# 9/16/2008 GAY DITCH FLUME

#### ASSESSMENT

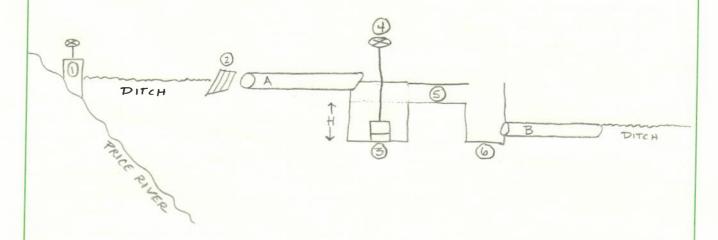
- (5) 9" PARSHALL FLUME (ACTULLY 8 ")

GAGE IS BOLTED INTO THE THROAT

SHOULD BE MOVED 4" TO READ @ 2/3 THROAT

METAL IS STARTING TO CORRODE
- 6 CONCRETE SUMP DRAINED BY 14" ID PIPE
- B 14" ID PIPE

- FLUME MEASURED FLOW 28% LOWER THAN WE MEASURED USING THE HARSH MCBIRNEY CURRENT METER.
- " WE WOULD LIKE THE ACCURACY IMPROVED BEFORE WE INSTALL THE AUTOMATED METER AND TELEMETRY.
- FOUR IMPROVEMENTS IDENTIFIED:
  - I. RAISE THE FLOOR OF SUMP 3 UP TO THE FLOOR OF THE FLUME, THIS SHOULD REDUCE TURBULENCE IN THE FLUME.
  - 2. SLOW THE FLOW THROUGH PIPE A. POSSIBLY INLET FLOW COULD BE RESTRICTED THROUGH A SUBMERGED ORIFACE.
    ALTERNATIVELY BAFFLES COULD BE INSTALLED IN PIPE A.
  - 3. PLACE AUTOMATED MONITORING IN CORRECT LOCATION IN THROAT.
    ADD GAGE THERE FOR MANUAL MONITORING.
  - 4. ADD WING WALLS TO THE FLUME, TURBULENCE IN THE SUMP CORNERS SHOULD BE REDUCED.

FILL IN CORNERS WITH CONCRETE OR BY BOLTING METAL PLATES, CORNERS SHOULD BE FILLED TO A LEVEL EVEN WITH THE TOP OF THE FLAME.

\* RAISE THE FLOOR OF THE SUMP UP TO THE LEVEL OF THE FLOOR OF THE PARSHALL FLUME. LEAVE A "WELL" AROUND THE SLUICE GATE SO THAT IT MAY CONTINUE TO BE USED TO REGULATE FLOWS.

· RE-INSTALL THE FLUME GAGE, THE FLUME STAFF GAGE SHOULD BE LOCATED 233" FROM POINT SHOWN BELOW.
